Subject: Class II permissive change Request

FCC ID: 2APKV-518912

Pursuant to CRF Section 2.1043, Aduro Technologies LLC requests a Class II permissive change to update the filing. All of the changes are not effect to the RF performance, function and power.

Original: 81812-V2

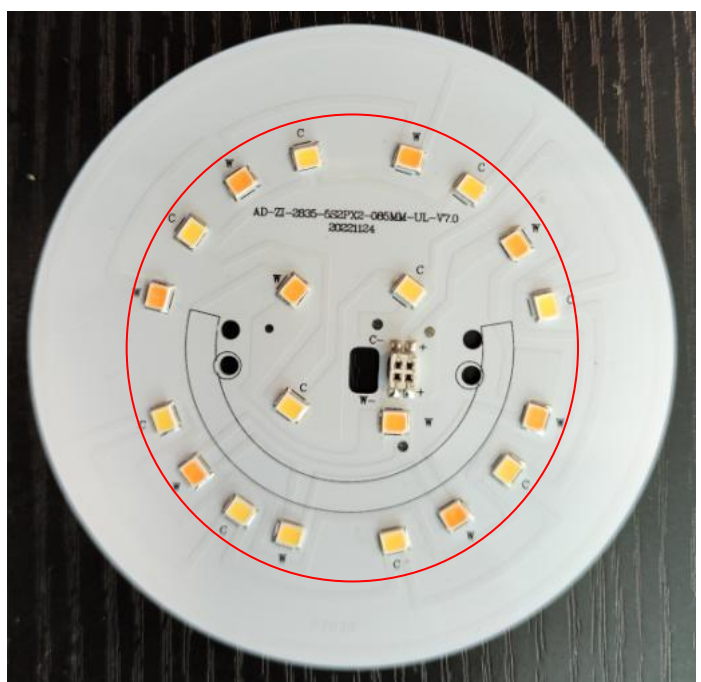
1. Different shapes ;
2. LED PCB different sizes ;
81812-V2: Ø39mm
81814-V2: Ø85mm
3. LED different amount ;
81812-V2: 12+12
81814-V2: 10+10
4. LED PCB different layout ;
5. Drive PCB different layout ;
6. Drive PCB different sizes ;
81812-V2: 45.5*31.5mm
81814-V2: 45.5*34.0mm
7. Different power ;
81812-V2: 8.5W
81814-V2: 10W
8. Change product name and model number

Comparison between the old and new photos and circle the differences
